Access Compliance Report

Public Rights-of-Way (Curb Ramps)

Intersection ID: 50591	Main Street: GREEN_GRASS_RD	Cross Street: LONGSTRAW_RD	Location: NW
ADA ID: 624E2B9D74AF	Ramp Type: Perp	Initial Pass/Fail: Fail	Overall Compliance: No
		Severity Score: 12.5

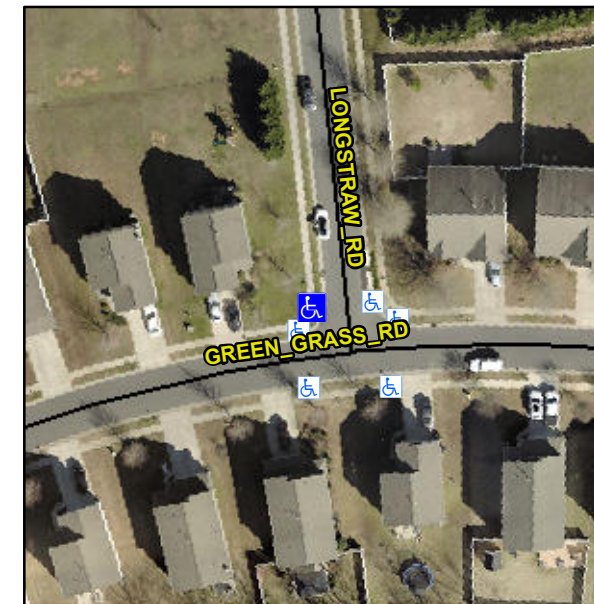
Compliance	Description	Data	Compliance	Description	Data
N/A	Ramp Length (in)	48.0	No	Ramp Slope (%)	9.0
Yes	Ramp Width (in)	48.0	Yes	Ramp XSlope (%)	1.3
N/A	Flare Type LT	N/A	N/A	Flare Type RT	N/A
N/A	Flare Slope LT (%)	N/A	N/A	Flare Slope RT (%)	N/A
N/A	Flare Traversable LT?	N/A	N/A	Flare Traversable RT?	N/A
N/A	Landing Length (in)	N/A	N/A	DWS Provided?	N/A
N/A	Landing Width (in)	N/A	N/A	DWS Contrast?	N/A
N/A	Landing Slope (%)	N/A	N/A	DWS Length (in)	N/A
N/A	Landing X Slope (%)	N/A	N/A	DWS Full Width?	N/A
N/A	Landing Curb? (Y/N)	N/A	N/A	DWS Offset (in)	N/A
N/A	Shared Landing?	N/A			
N/A	Gutter Ponding?	N/A	N/A	Gutter Slope (%)	N/A
N/A	Gutter Lip Ht (in)	N/A	N/A	Gutter X Slope (%)	N/A
N/A	Painted X Walk1?	No	N/A	Painted X Walk2?	N/A
	X Walk 1 Direction	To E		X Walk 2 Direction	N/A
N/A	X Walk 1 Width (in)	N/A	N/A	X Walk 2 Width (in)	N/A
	X Walk 1 Slope (%)	3.3		X Walk 2 Slope (%)	N/A
	X Walk 1 X Slope (%)	0.9		X Walk 2 X Slope (%)	N/A

Remove & Replace Entire Ramp.

R304.2.2
